P1394a  
December 1997

# FIFO Centering

Colin Whitby-Strevens

## Dribble bits

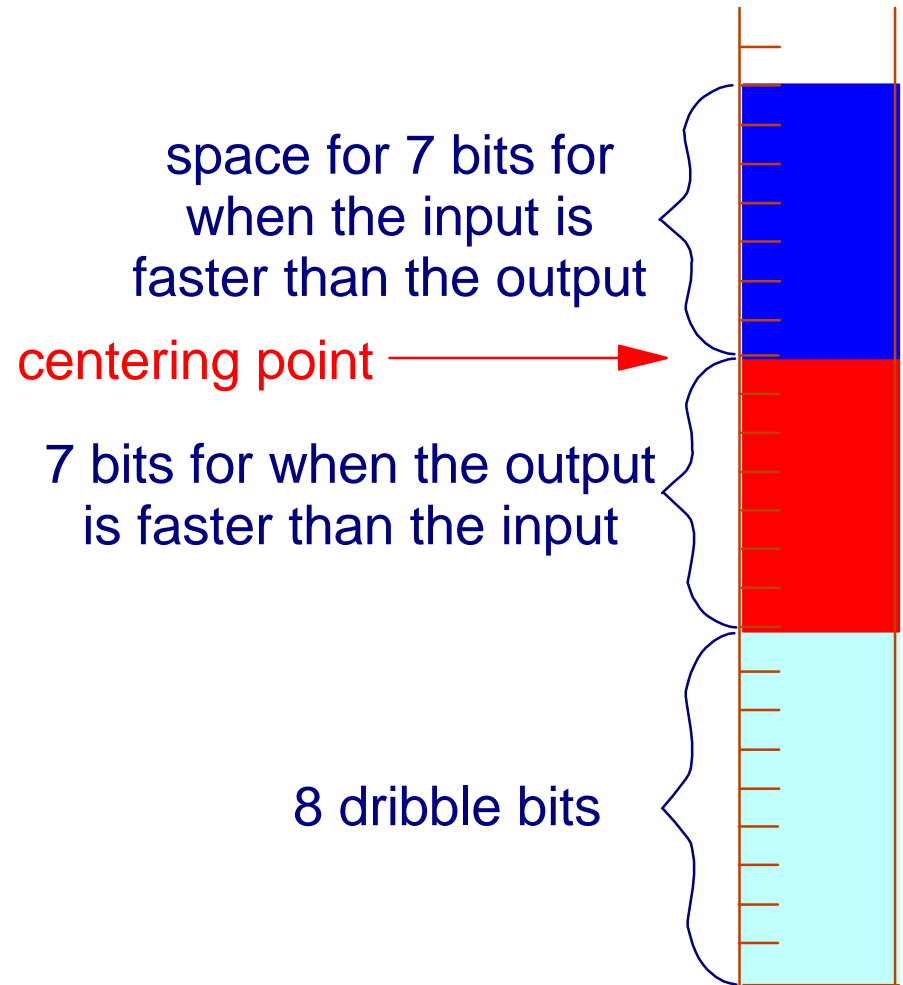
- ▢ Dribble bits need to be taken into account
  - "Empty" test is when there are only dribble bits left in the FIFO
    - ✓ test made on count of bits
    - ✓ need to ensure that there are always more than "dribble bits" in the buffer until the end of packet

- 2 for S100, 4 for S200, 8 for S400
